**Appendix A:
Notice of Preparation and Responses**

**NOTICE OF PREPARATION OF A
DRAFT PROGRAM ENVIRONMENTAL IMPACT REPORT
FOR THE
WARM SPRINGS SOUTH FREMONT COMMUNITY PLAN**

Warm Springs South Fremont Community Plan Program EIR Review

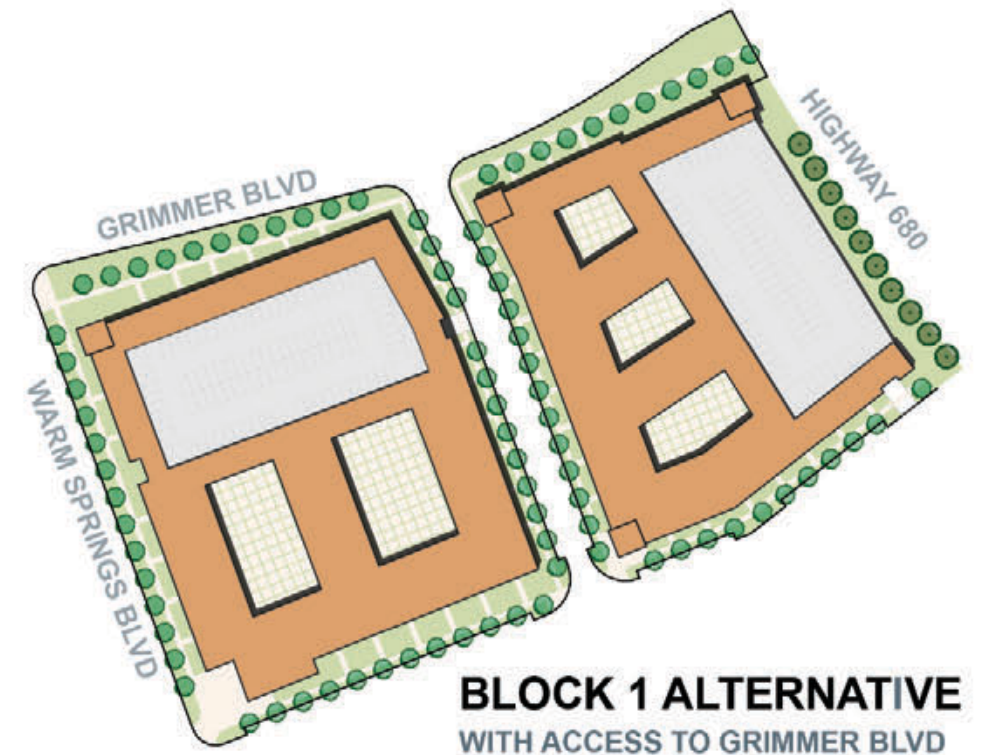
2. The Proposed Site Plan has a frontage road, which is designed similar to a multi-way boulevard. This frontage road will allow for slow moving vehicles and bikes to proceed parallel to Warm Springs Boulevard, enabling access to retail parking, the public park and also provides for visitor parking along Warm Springs Road. This is very similar to a recently approved configuration across from the Pleasanton BART Station, which was developed as

part of the Pleasanton BART Station Plan with residential, retail and live/work uses within the Hacienda Business Park. We request that the City consider this circulation concept as part of the Warm Springs/South Fremont Community Plan, circulation plan.
